## Victorian System Strength Requirement Project Specification Consultation Report

David Beavers  
General Manager, Network Infrastructure  
AusNet

## AusNet submission in response to the Victorian System Strength Requirement PSCR

Figure 1: Areas of the Victorian network that are least likely to receive maintenance outage approvals.

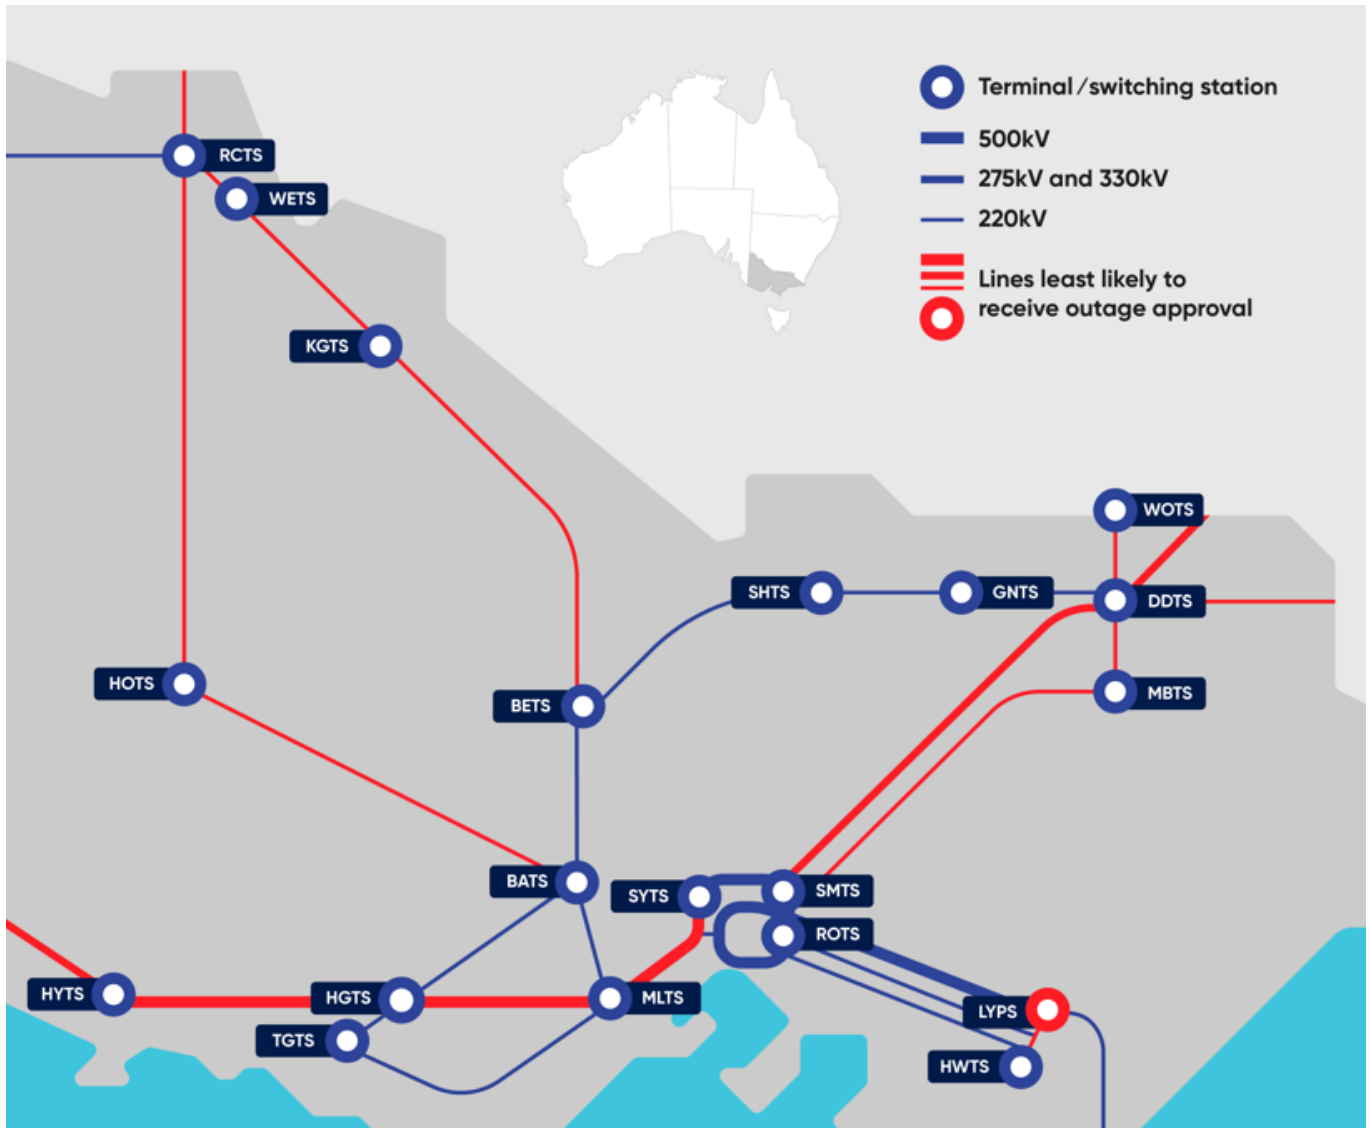
In addition to reducing outage windows, these issues have made it near impossible to schedule network outages on inter-regional support equipment, and more recently on the 330 kV network in the Central North REZ (V6). The figure below outlines the areas of the Victorian network that are least likely to receive outage approval.

outage. We anticipate this would be particularly beneficial given there are few declared system strength nodes in areas of the Victorian network that are least likely to receive outage approval – see Figure 1.
